**APPLICATION NO. A/NE-TK/837 FOR PERMISSION
UNDER SECTION 16 OF THE TOWN PLANNING ORDINANCE**

Section 16 Application No. A/NE-TK/837

Annex 1 - Response to Comments Table

Section 16 Application for Temporary Public Vehicle Park (Private Cars Only) with Ancillary Electric Vehicle Charging Facilities and Ancillary Solar Panels and Associated Filling of Land for a Period of 3 Years at Lot No. 241 in D.D. 23 at Ting Kok, Tai Po, New Territories

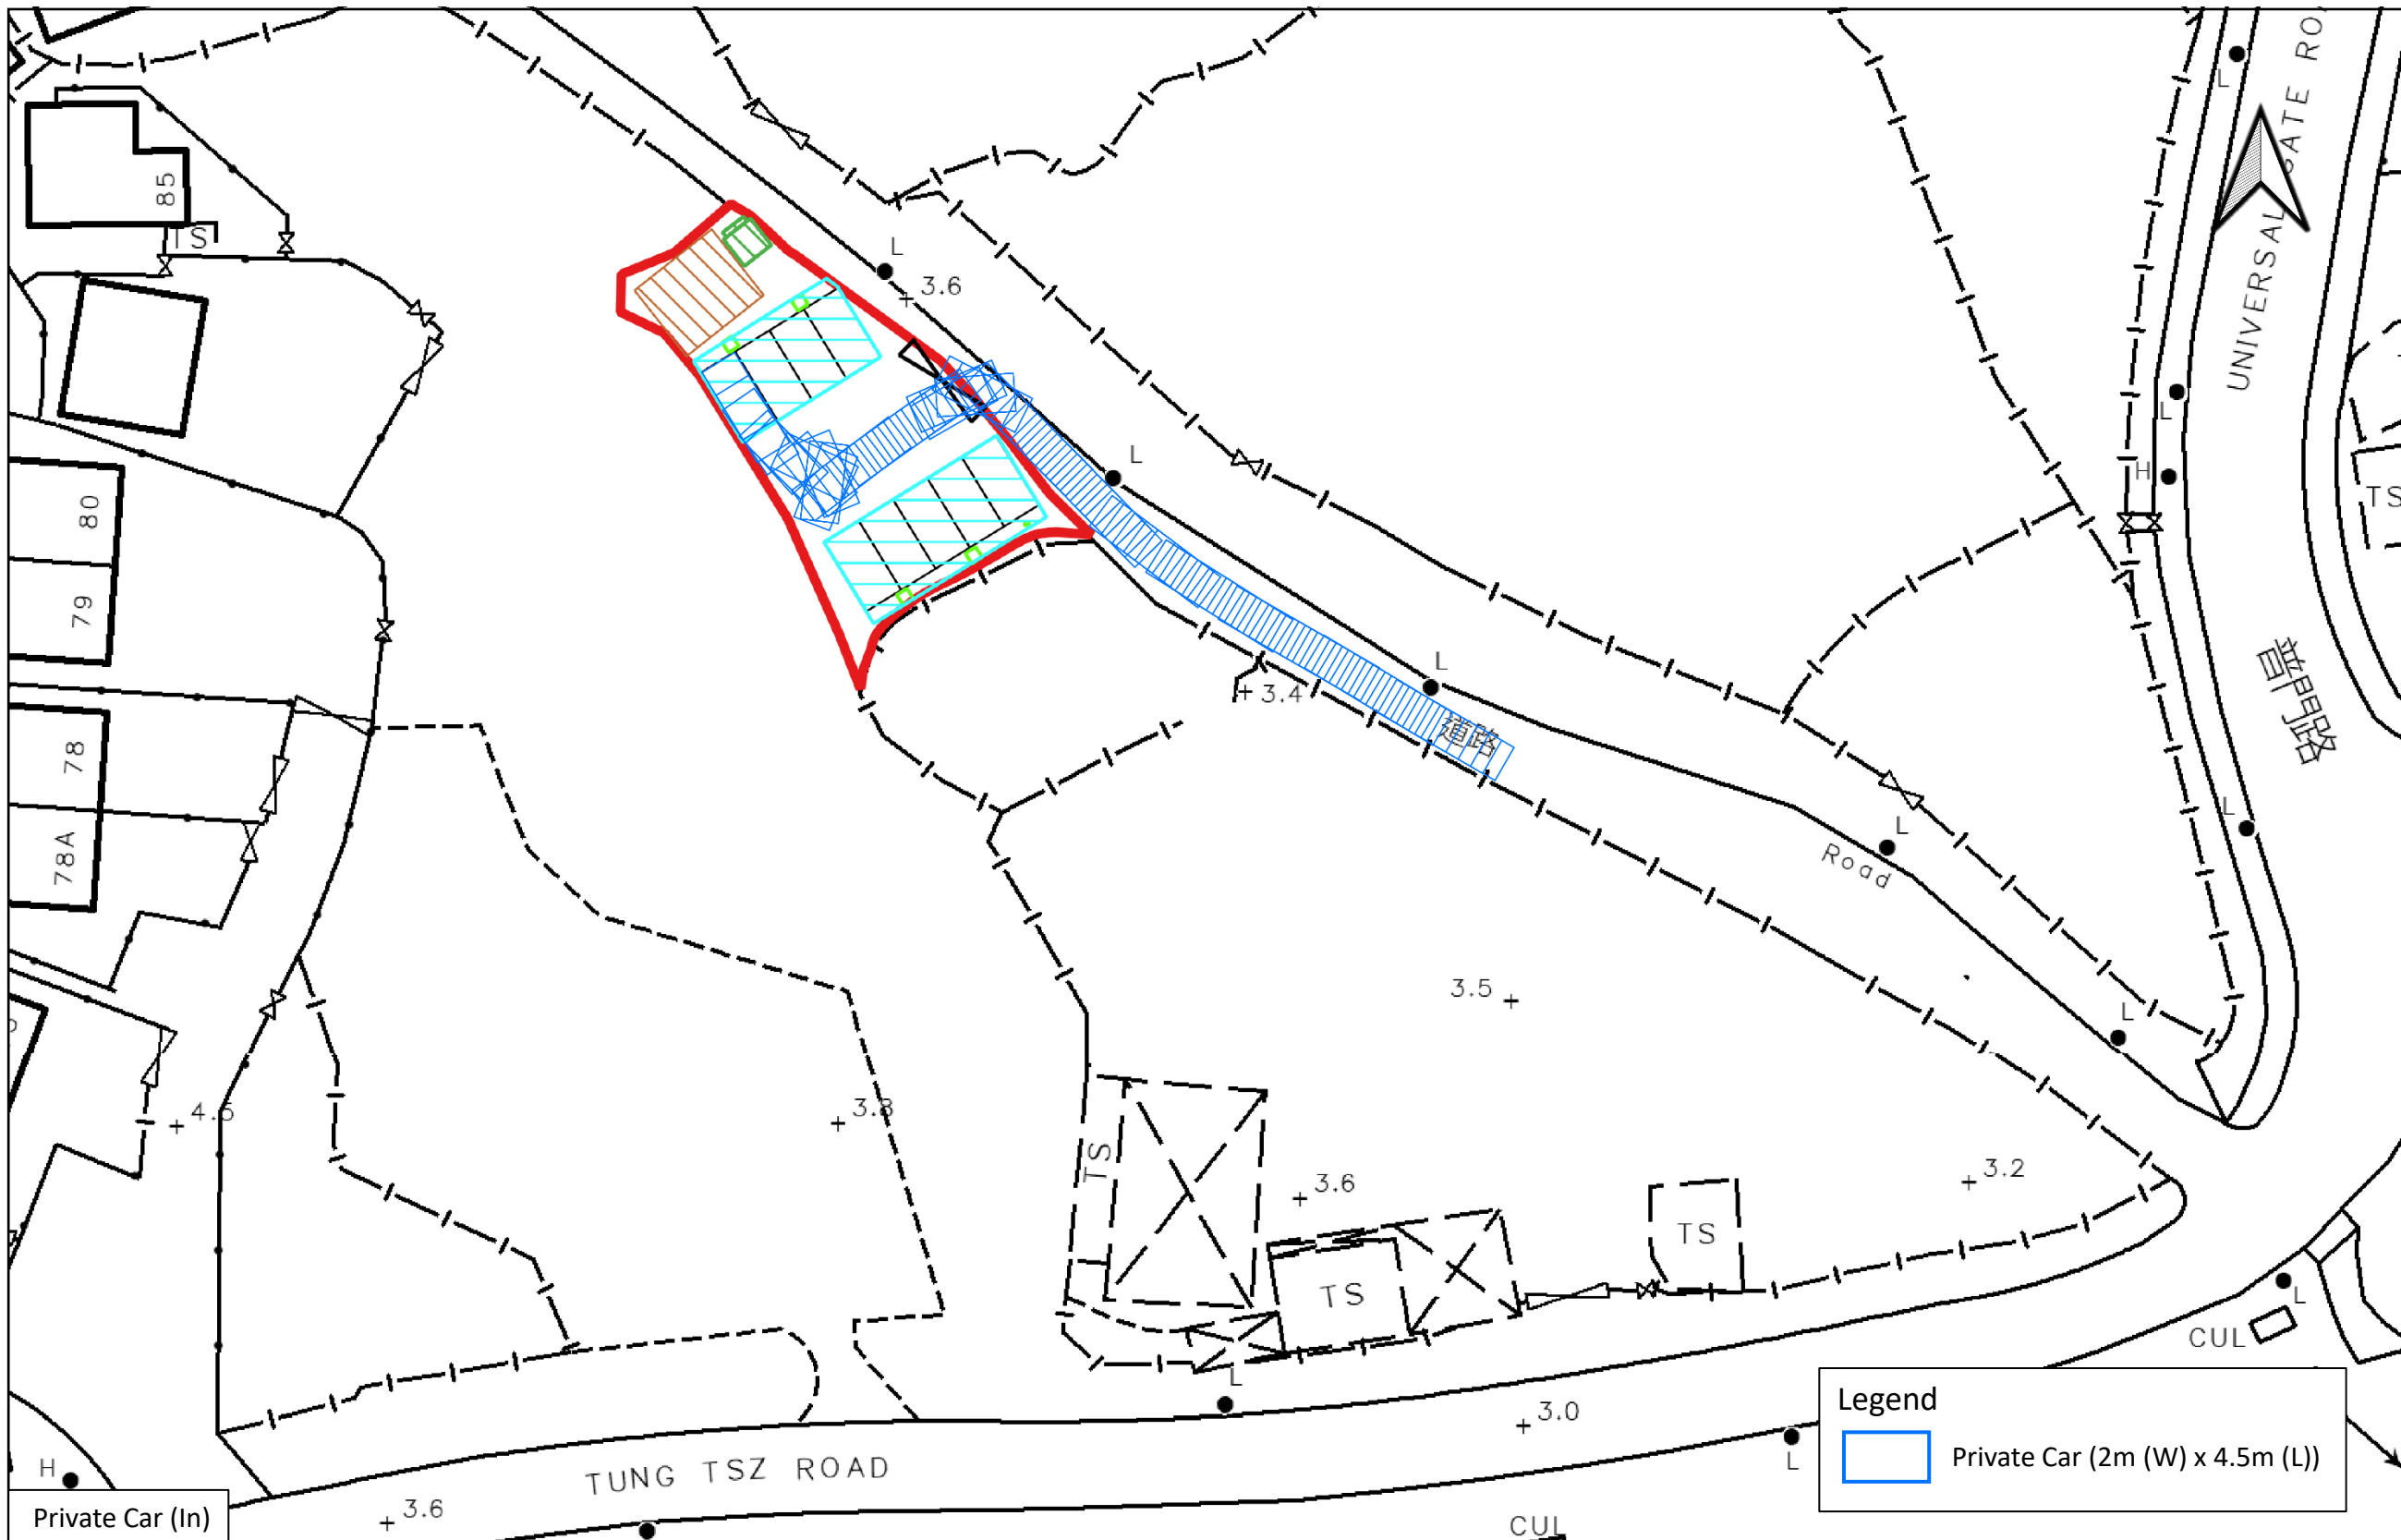
3.	<i>Comments from Transport Department received on 25 August 2025</i>	
m	The number of vehicular access for a development site shall be limited to one from traffic management viewpoint. The applicant shall review the number and location of the vehicular access.	Noted, the indicative layout plan in Annex 2 has been revised according to the departmental comment.
n	The applicant shall indicate on plan clearly whether there is boundary fence/wall and demonstrate the maneuvering of vehicles does not clash with the fence/wall. The swept path analyses clashes with both black line and red line on plan which indicates vehicles have to go beyond the proposed 6m wide ingress/egress when entering or leaving the site.	Noted, the indicative layout plan and the corresponding swept path analysis in Annexes 2 and 4 have been revised to reflect departmental comment. There will be bollards instead of fences to define the site boundary and entrance, ensuring no conflicts with fences or walls during vehicle entry or exit. The swept path analysis is provided for indicative purposes only.
